TRANS/WP.29/2001/61
24 August 2001

PROPOSAL FOR DRAFT SUPPLEMENT 2 TO THE 01 SERIES
OF AMENDMENTS TO REGULATION No. 67

(Equipment for liquefied petroleum gas)

Figure 3: connecting area of the light vehicle Euro filling unit"

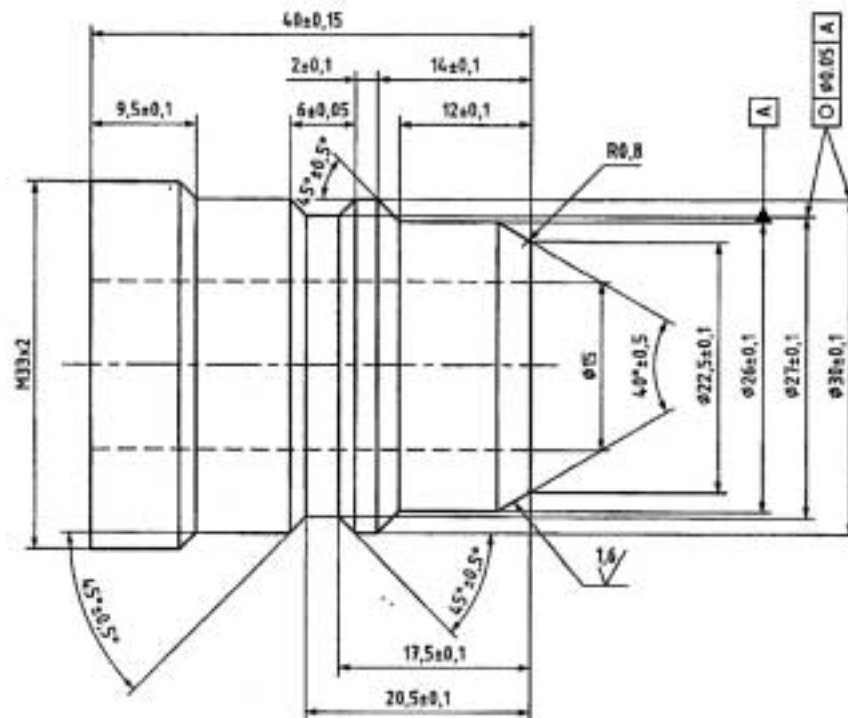
"6.15.10.6. Specific provisions regarding the light vehicle Euro filling unit (Annex 9 - Figure 3):

6.15.10.6.1. The dead volume between the front sealing surface and the front of the non-return valve shall not exceed 0.1 cm³;

6.15.10.6.2. The flow through the connector at a pressure difference of 300 kPa shall be at least 60 litres/min, if tested with water.

Insert a new Figure 3, to read:

Figure 5: Connecting area of the heavy-duty vehicle Euro filling unit"

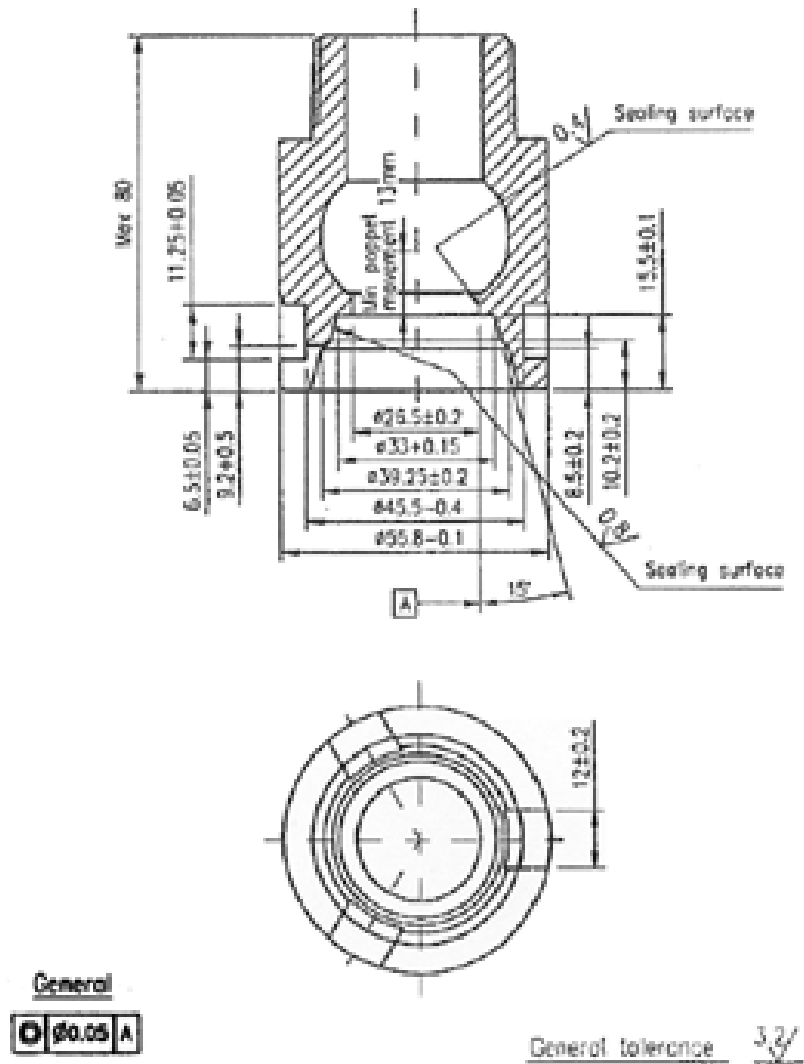
The filling unit shown in figure 5 is only applicable for motor vehicles of categories M2, M3, N2, N3 and M1 having a maximum total mass > 3,500 kg. */"

6.15.10.7. Specific provisions regarding the heavy-duty vehicle Euro filling unit (Annex 9 - Figure 5):

6.15.10.7.1. The dead volume between the front sealing surface and the front of the non-return valve shall not exceed 0.5 cm³;

6.15.10.7.2. The flow through the filling unit, with the non-return valve mechanically opened, at a pressure difference of 500 kPa shall be at least 200 litres/min, when tested with water."

Insert a new Figure 5, to read:
